**Director's Report**

Project Name: Lakepointe  
 Description: Final site plan and PDA re-approval  
 Date on Agenda this packet pertains to: August 15, 2024

**RE: Lake Pointe – Final Site Plan and Final Engineering Plan –7<sup>th</sup> Review**

**RE: Lake Pointe – Final Site Plan Backcheck #4  
Parcel Number 12-36-177-003**

DRAWN BY  
 MS/DA  
 CAD FILENAME  
 2216.DWG  
 CHECKED BY  
 JOB NUMBER  
 2216  
 DATE  
 SHEET NUMBER  
 A201

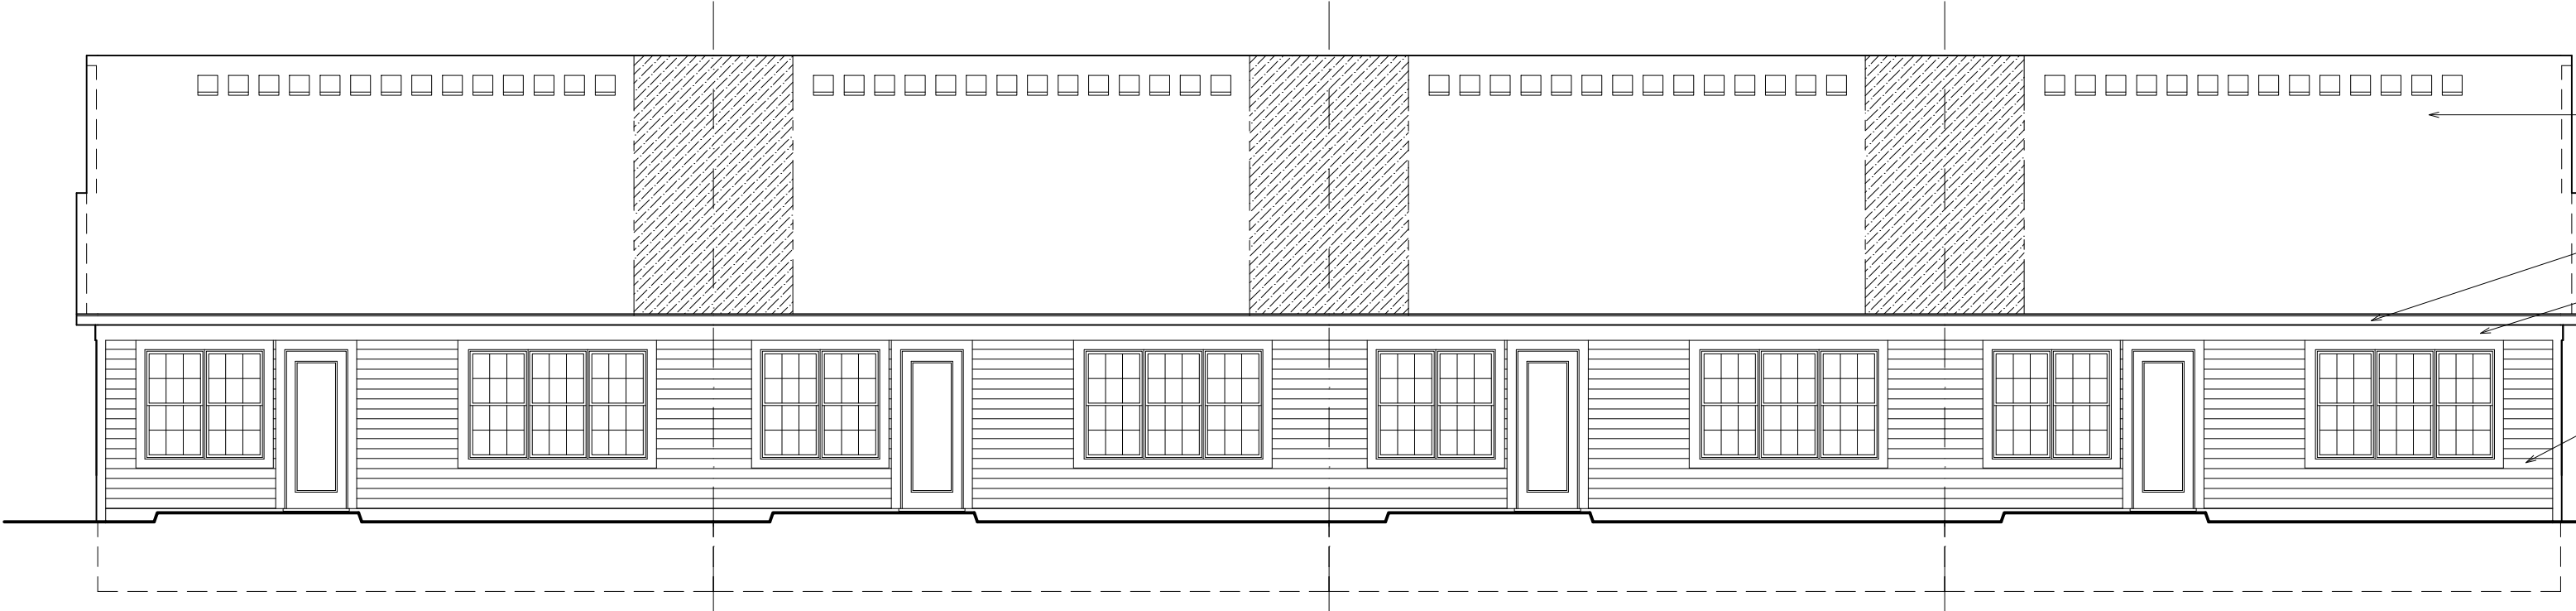
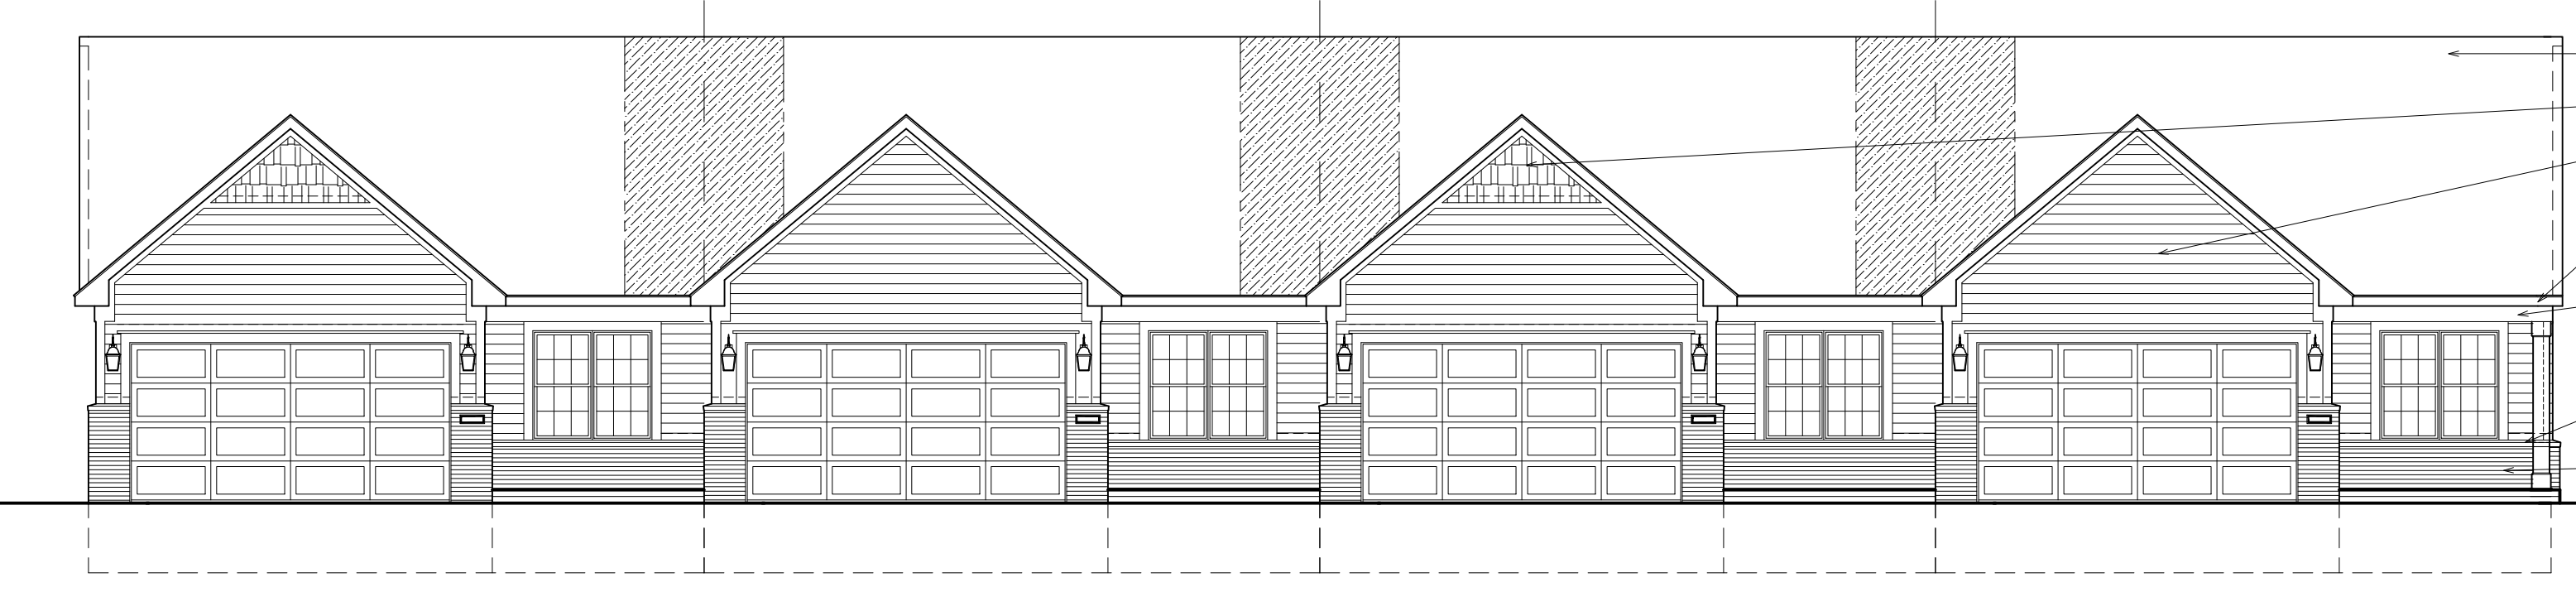
- As stated in previous correspondence (dated February 22, 2021), **the building materials shall be labeled on the building elevations, Sheets A201 and A203.** (Comment outstanding). (Comment remains outstanding). (Comment addressed. Material notations have been added to the elevations).
